**RE: Westmount Development – Revised Sketch Plan
Response Letter**

MODIFICATION REQUESTS
FOR
WESTMOUNT DEVELOPMENT
REVISED SKETCH PLAN
MOUNT JOY TOWNSHIP, LANCASTER COUNTY, PA
May 5, 2023
REV. July 10, 2023
REV. February 2, 2024
REV. May 14, 2024

Re: Westmount
Revised Sketch Plan
Township Permit No. 23-07-FLDP
LCEC Project No: 25-134

Revised Sketch Plan Review 2
Mount Joy Township, Lancaster County, PA
TPD No. MJTO.00076

PUMPER FIRE TRUCK
 SUBJECT:
TURNING MOVEMENT PLAN
 FOR
 WESTMOUNT
 MOUNT JOY TOWNSHIP, LANCASTER COUNTY, PA
 CLIENT:
VISTABLOCK, LLC
 150 FARMINGTON LANE
 LANCASTER, PA 17601
 (717) 682-8775

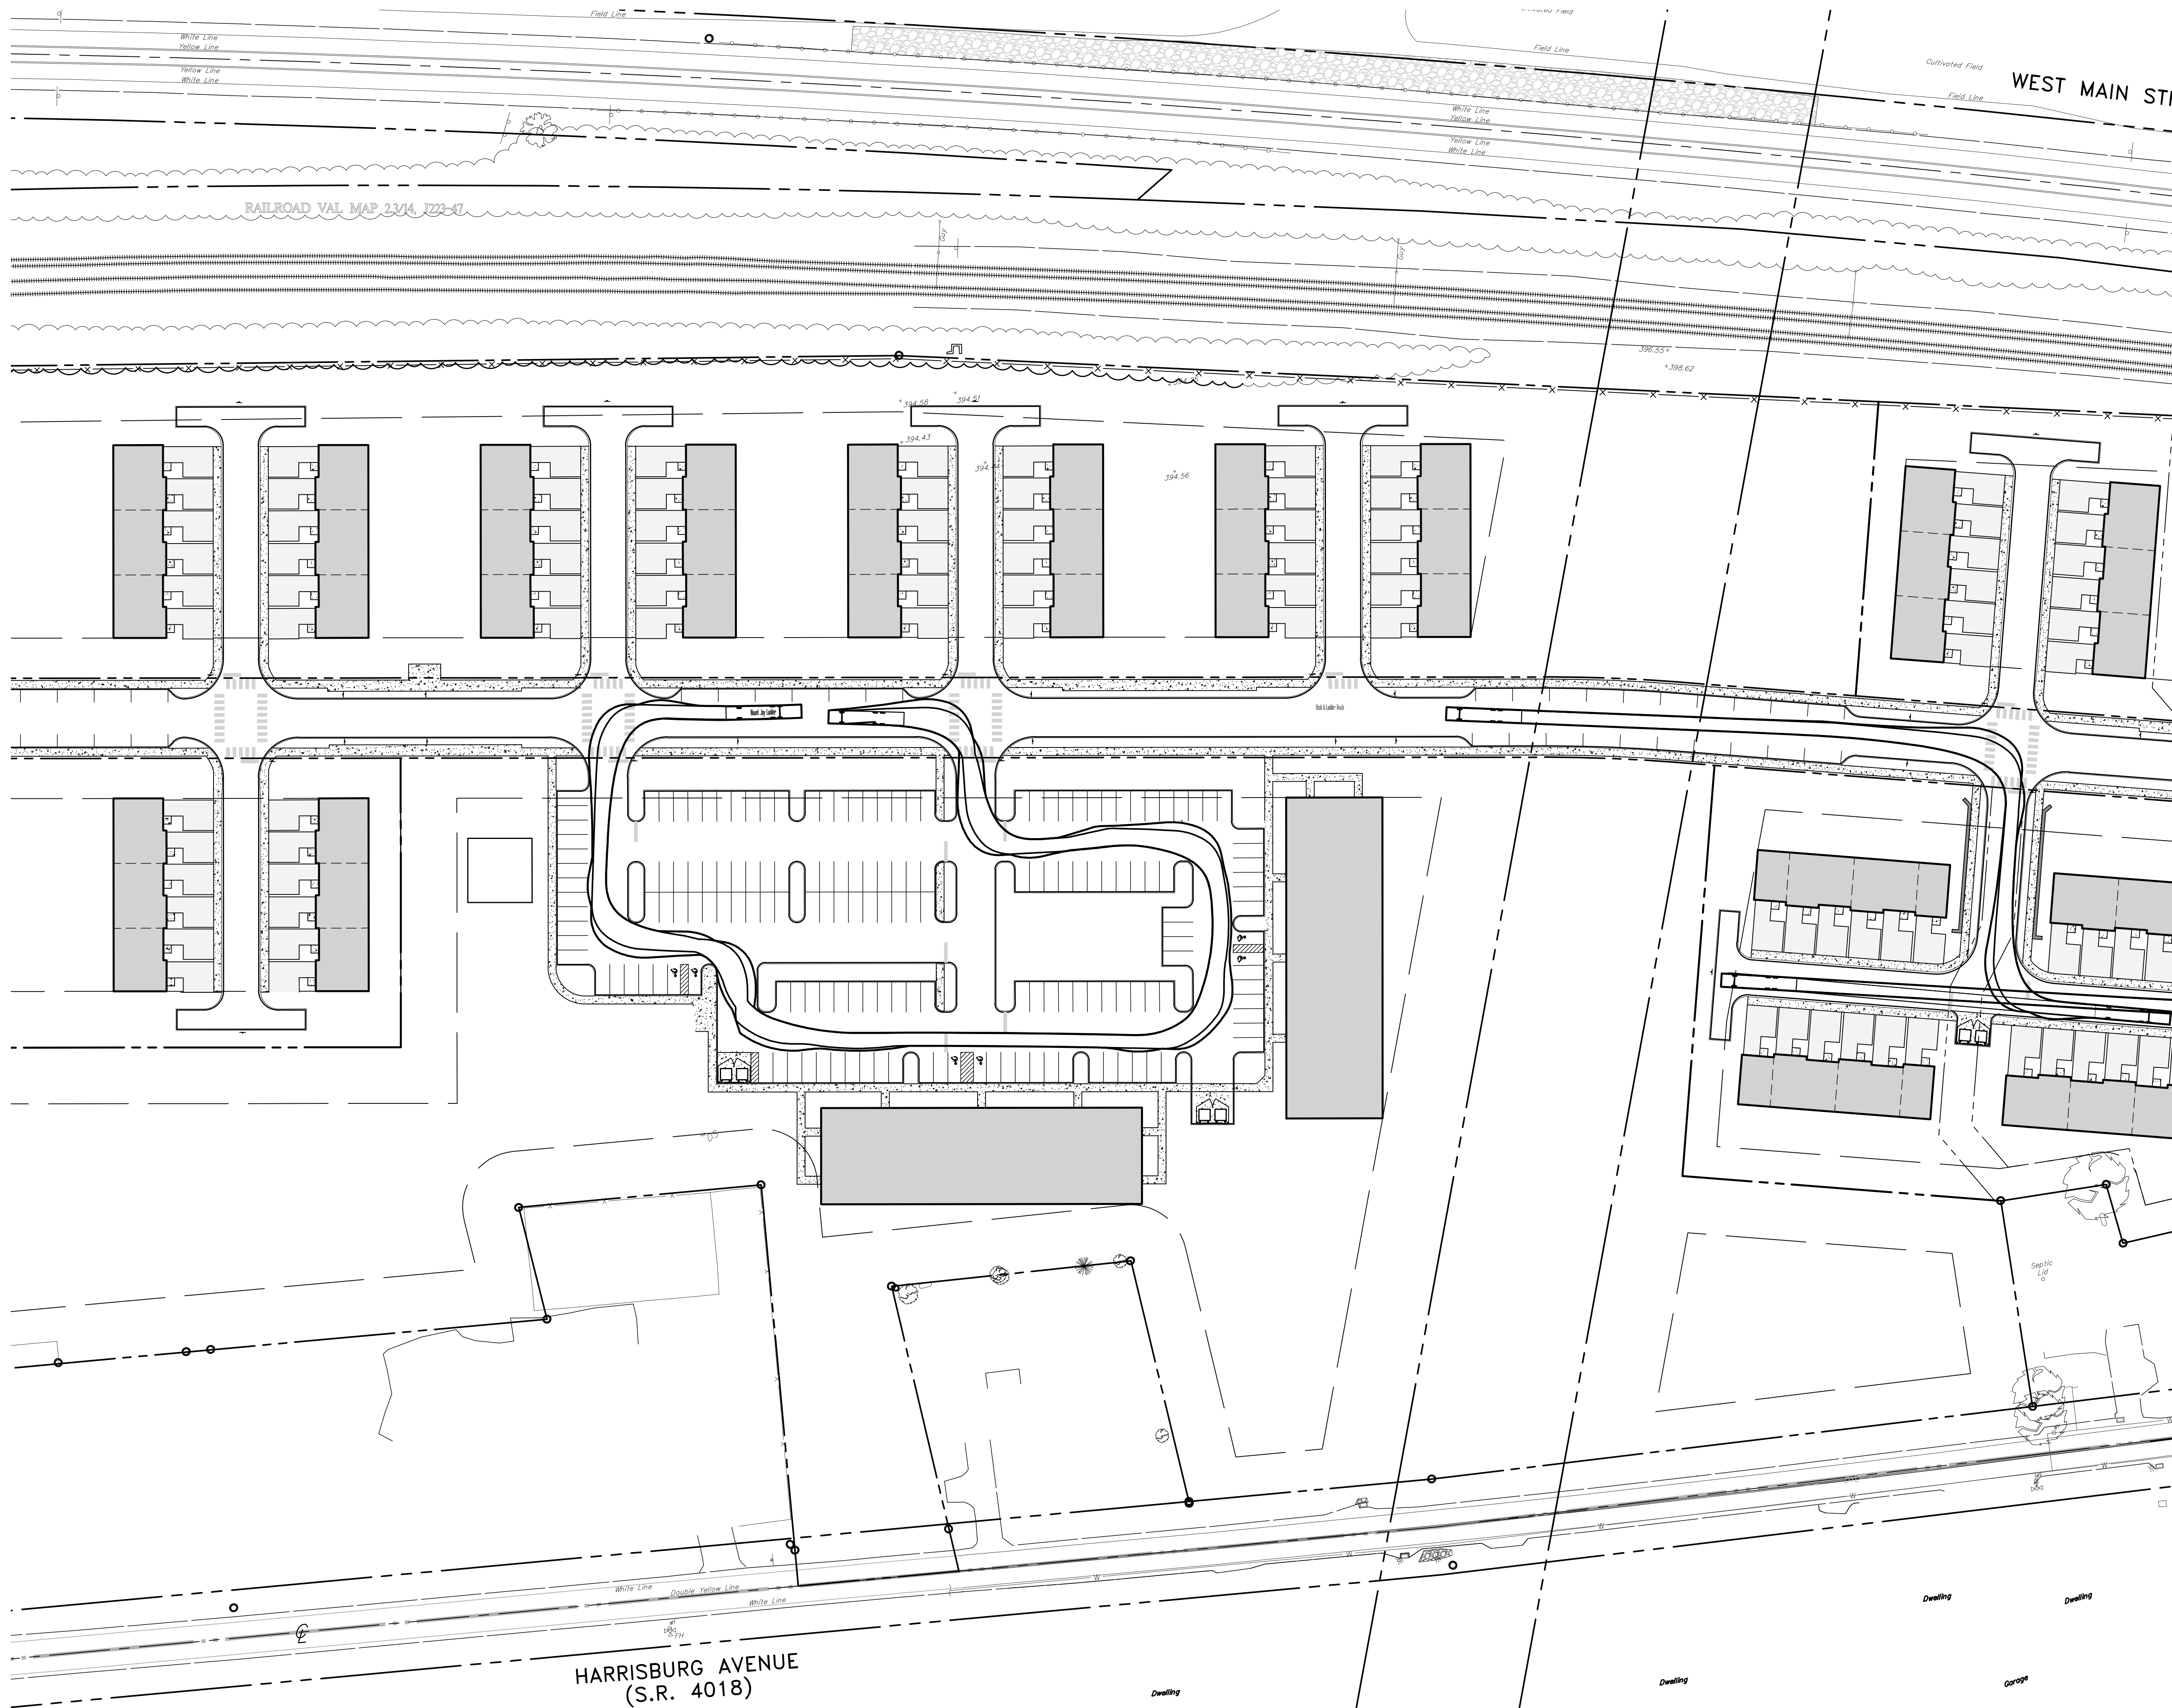
24. *The designer should consider options for discouraging excessive speeds along Bradfield Drive (119-53.D(3)). There appears to be an opportunity to provide a more curvilinear design if the street fronting Lot 4 was shifted to the south. This would also serve to provide greater separation from the railroad right-of-way for several of the townhouses on Lot 6. Additionally, the designer may want to consider the opportunity to shift all of the townhouses on Lot 6 to the south if the location of the apartment buildings and the townhouses on Lot 4 were switched so that a longer portion of Bradfield Drive could be shifted to the south.*

Likewise, we have no concerns with the turning movements throughout the development. There is ample space for apparatus to access and egress the various buildings and with the addition of the "hammerhead" areas at the end of each access drive, it will allow us to operate as we normally do.

VEHICLE TURNING ACCESS EXHIBIT - AMBULANCE @ HAMMERHEAD
 VISTABLOCK WESTMOUNT, LLC - WESTMOUNT DEVELOPMENT - MOUNT JOY TOWNSHIP

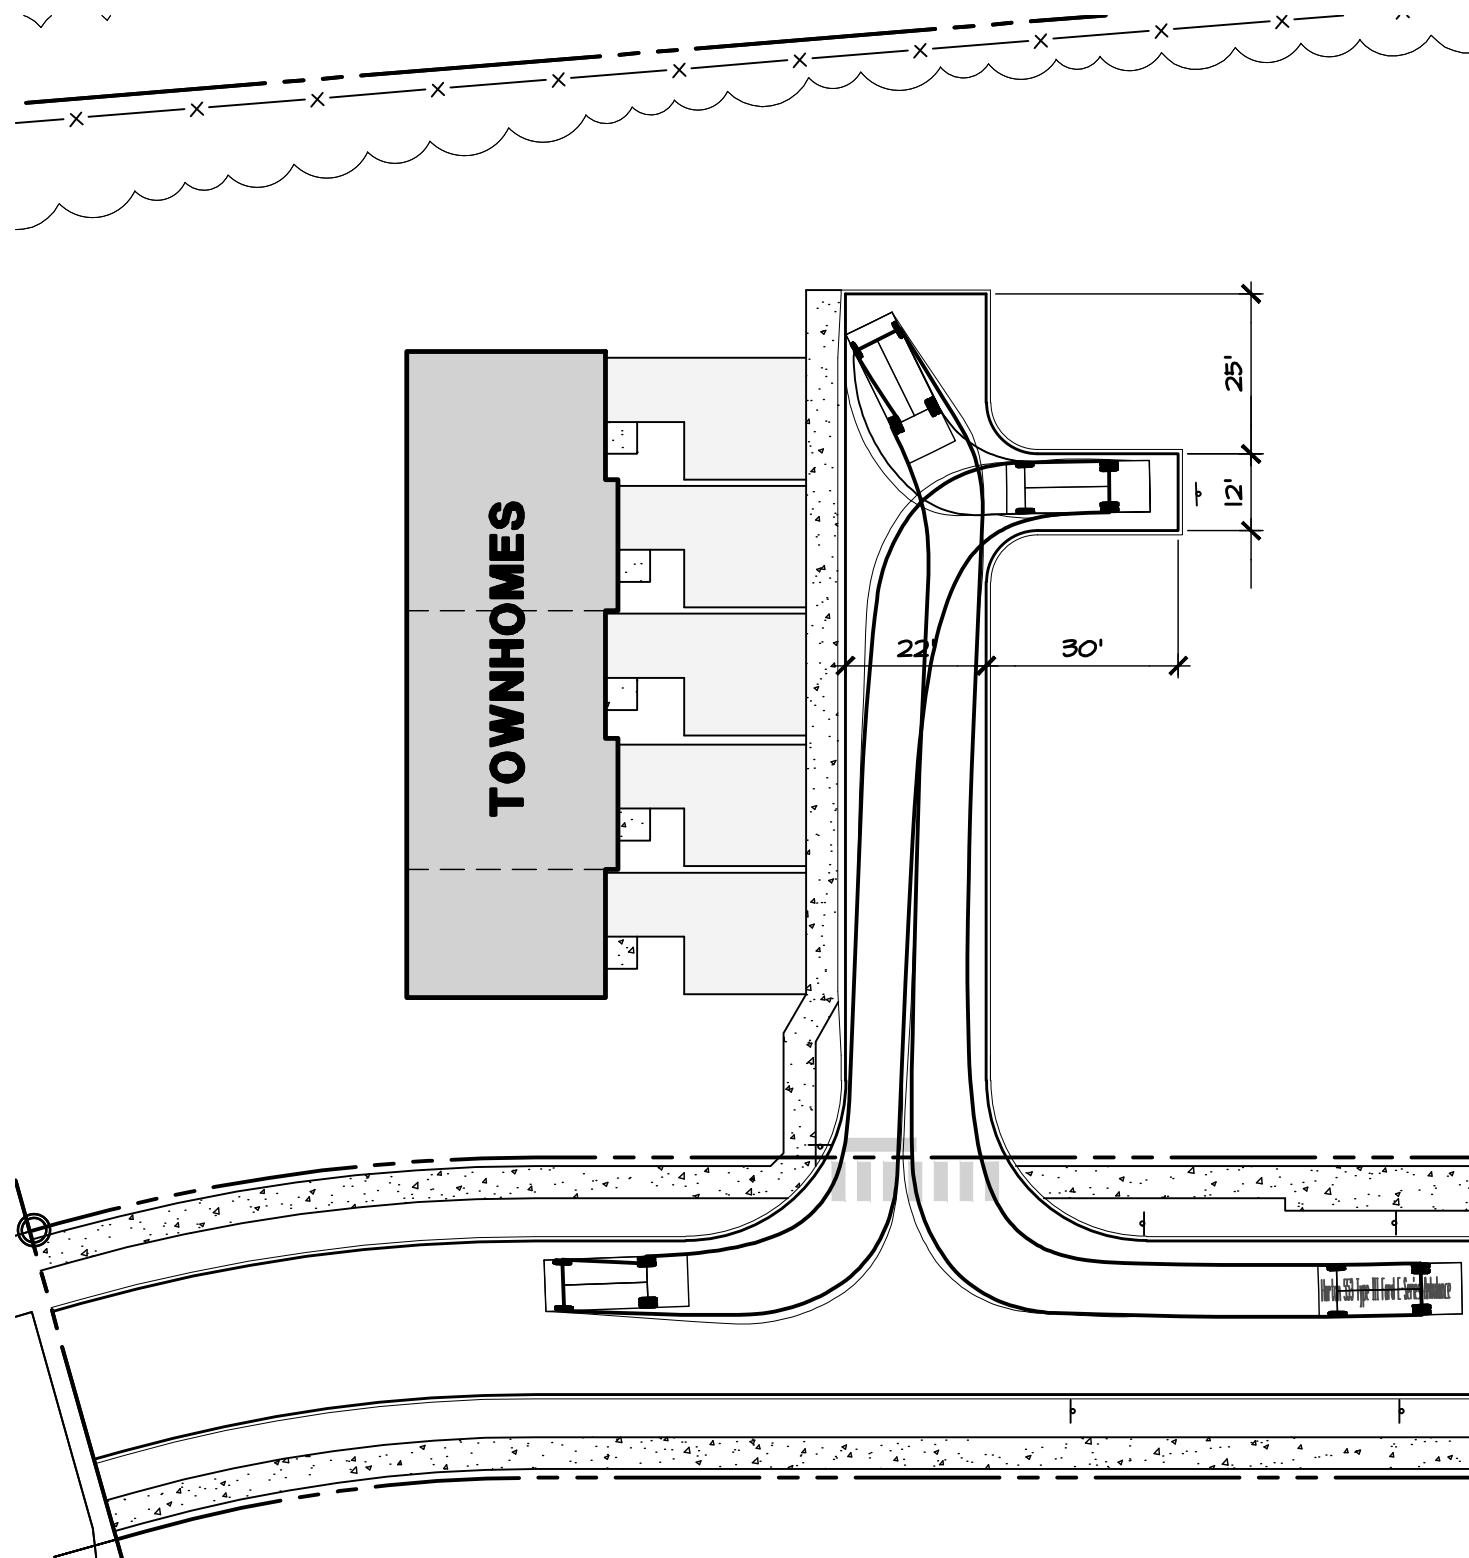
6. *Written notices from the emergency service providers that will serve as the primary responders for the land development shall be submitted indicating that the building layout is satisfactory and will not present any obstacles or other problems for emergency responders to the land development (119-35.E.(2)(h) & 135-262.G(2)). It appears the proposed access drives do not provide sufficient turnaround areas for emergency service vehicles.*

The updated plan now provides "Hammerhead" turnarounds at the end of each townhouse grouping to accommodate an ambulance or standard box truck. (See attached Exhibit) Regarding Fire Dept., Owner/Developer, Brandon Conrad of Vistablock and I met with the primary fire emergency responder, Rheems Fire Co. on

REVISED SKETCH PLAN
 SUBJECT:
COVER SHEET
 FOR
 WESTMOUNT
 MOUNT JOY TOWNSHIP, LANCASTER COUNTY, PENNSYLVANIA
 CLIENT:
VISTABLOCK, LLC
 150 FARMINGTON LANE
 LANCASTER, PA 17601
 717-682-8775

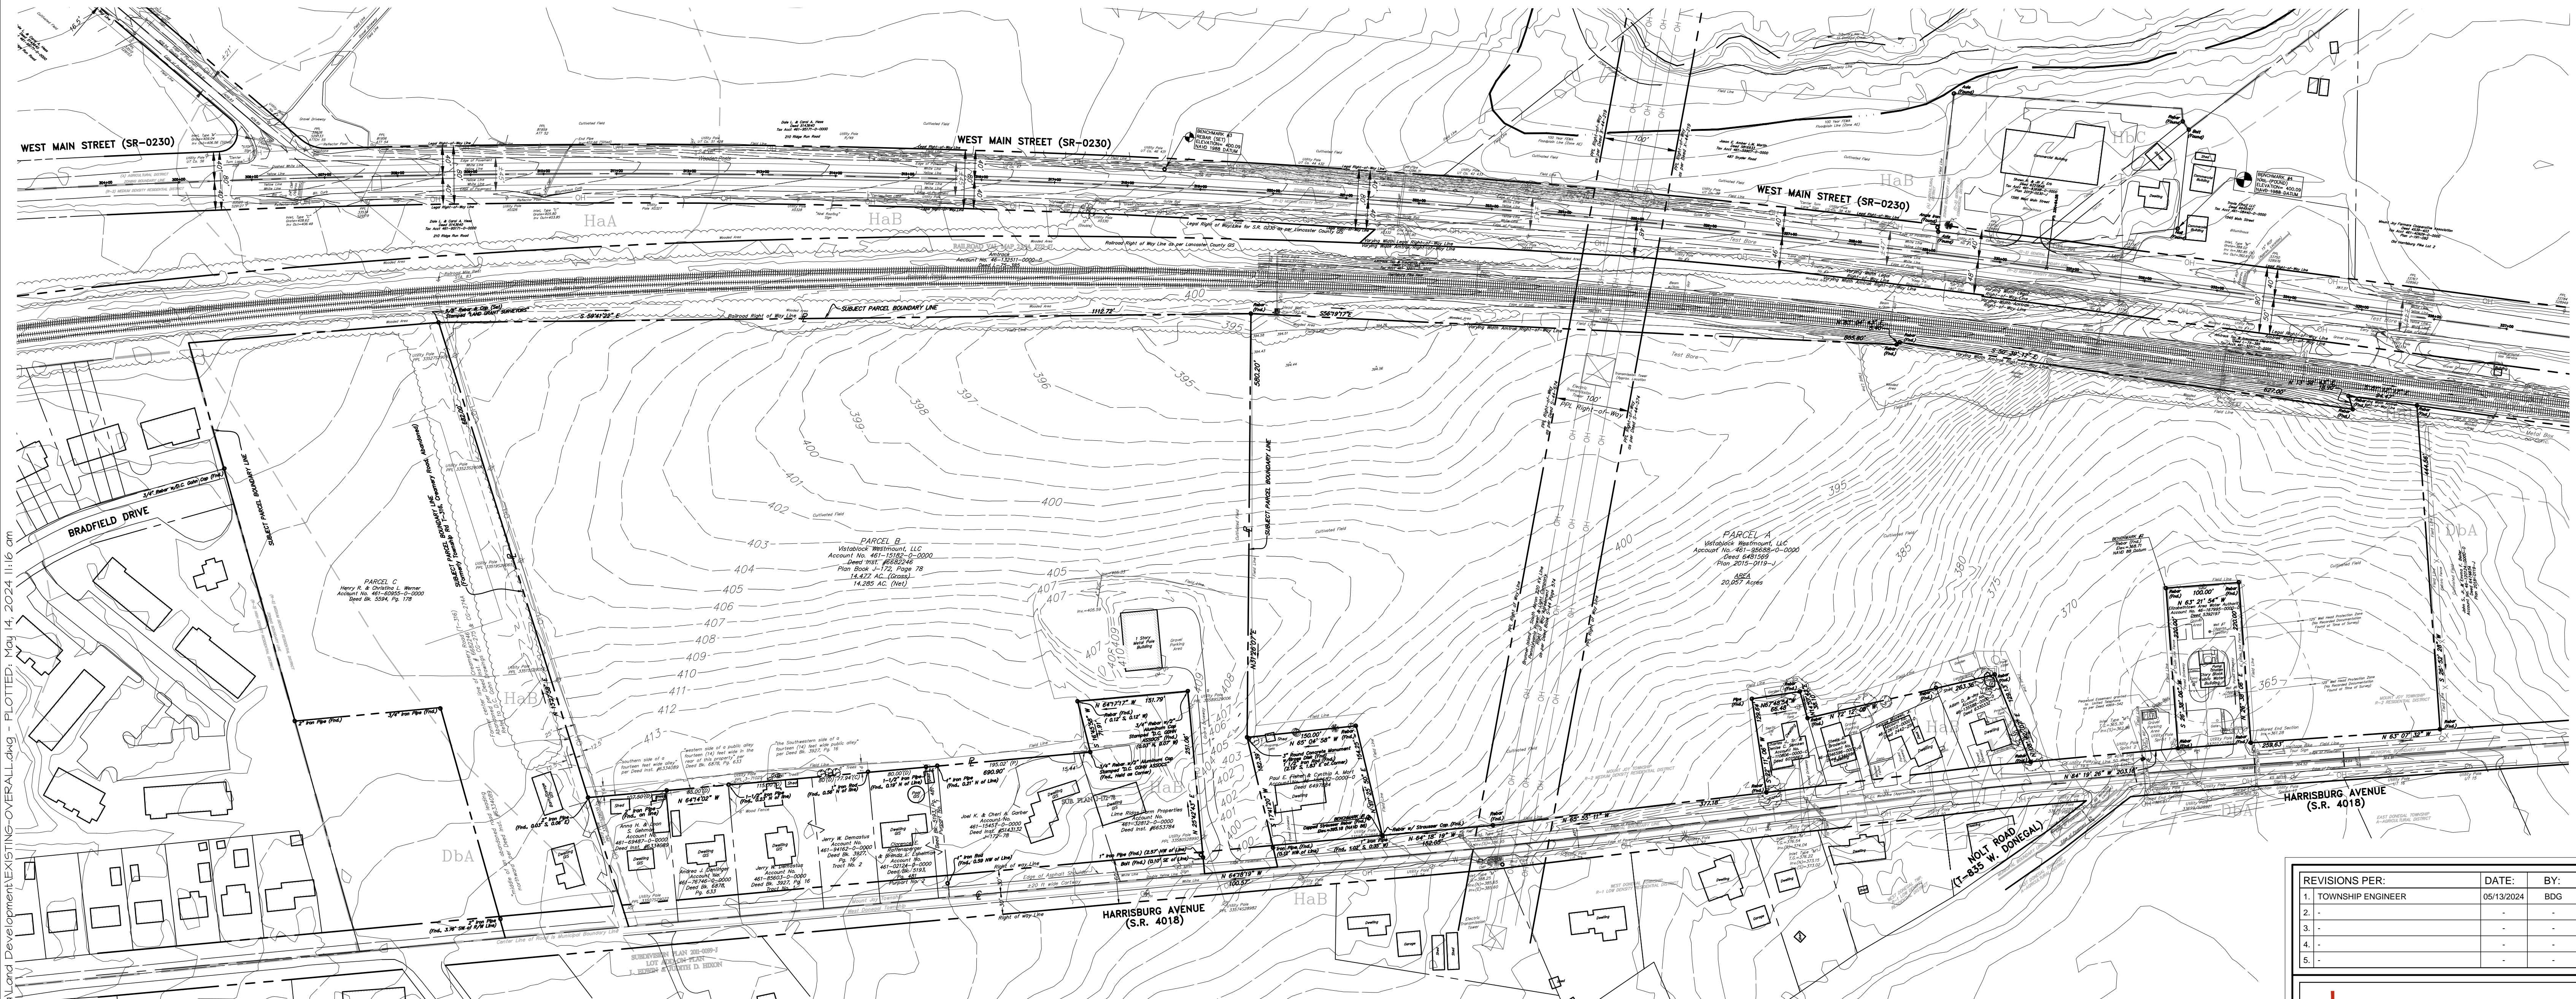
4. *A garage shall be considered a parking space only if access can be provided without needing to move any other vehicle (135-342.B). The number of proposed spaces for the Single-Family Attached use shown in the Parking Data table on the Cover Sheet shall be consistent with this requirement.*

5. *The proposed land use shall be provided on the plans for Lot 5 (i.e. Werner Lot) (119-31.D(3)).*

The garage spaces have been removed from parking space computation and the chart on the Cover Sheet has been updated to reflect this parking space number revision.

Lot 5 (Werner Lot) will remain as a Single-Family Use. This has been updated on the Site Data Chart on the Cover Sheet.
